**Tasmanian Planning Scheme – Brighton
Draft Amendment RZ 2022-005**

Appendix A - Council's Response to Directions for draft amendment RZ 2022-05

Figure BRI-S11.2 The South Brighton Specific Area Plan Development Framework

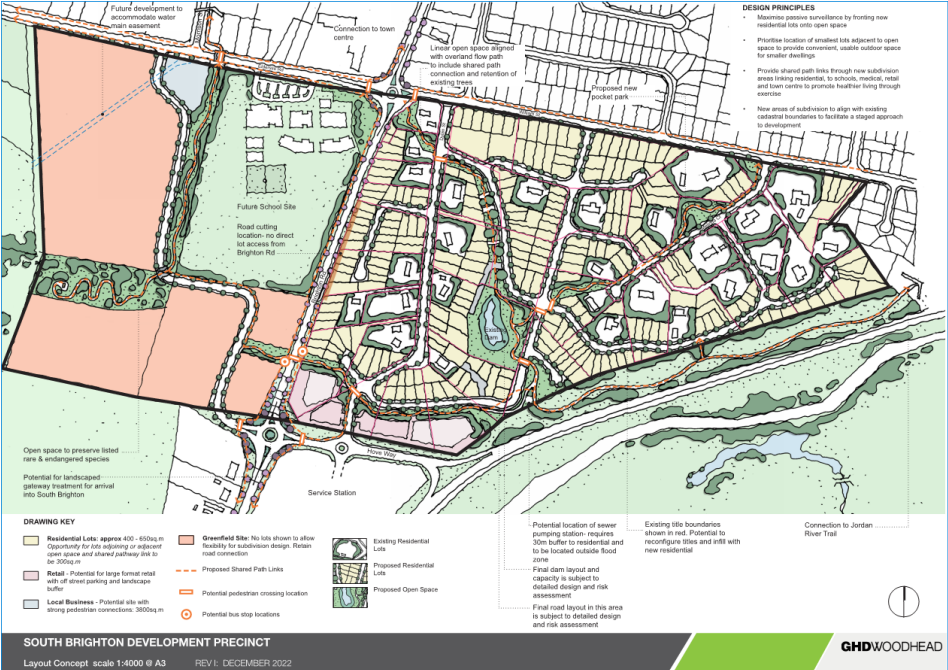
3.0	<p>In clause BRI-S11.4, include definitions for:</p> <ul style="list-style-type: none"> • ‘Development Framework’ referencing Figure BRI-S11.2 <p>‘Shared path link’</p> <p>And restructure in alphabetical order.</p>	<p>Definitions included as per below:</p> <p>Development Framework</p> <p><i>means the South Brighton Specific Area Plan Development Framework shown in Figure BRI-S11.2.</i></p> <p>Shared path-link</p> <p><i>Means an area open to the public that is designated for the use of pedestrians, cyclists and other personal mobility device users and links different areas as shown in the Development Framework.</i></p>
